OAKLAND AVENUE PEAKS ISLAND
84-C-9

APARTMENT HOUSE ZONE
CITY OF PORTLAND, MAINE

DEPARTMENT OF BUILDING INSPECTION

New Island Ave., Peaks Island (Assessors' Lot No. 84-C-9) - Alterations to Dwelling for Florence Tuttle by Donald DiBiase--10/21/55

PLAN (No Scale)

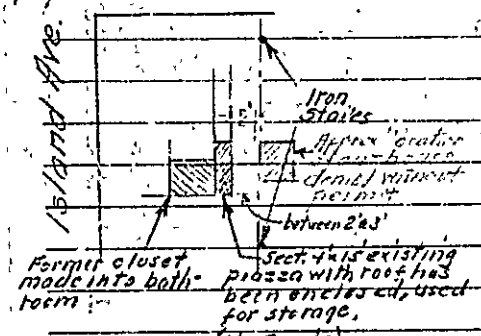
I talked with Mrs Tuttle and above sketch is situation as she described it to me.

Two questions arise, the matter of lot line and of work done without a permit.

As to lot line there are two iron stakes clearly marking Mrs Tuttle near line. The complainants claim Mrs Tuttle has moved these. It seems this is clearly a matter for them to settle between themselves.

Regards work done without a permit, there is a defin. improvement in [illegible] as been done. If the enclosed piazza work on the complainants land, the outhouse removed certainly very, and conditions so much better I would be inclined to forget the whole thing. The wording of the permit is not correct as to new bath and should be changed.

It seems to me it would be well to write the complainant and explain the result of our inspection and inform her that the matter of questionable lot line, especially since there are stakes would be up to here.
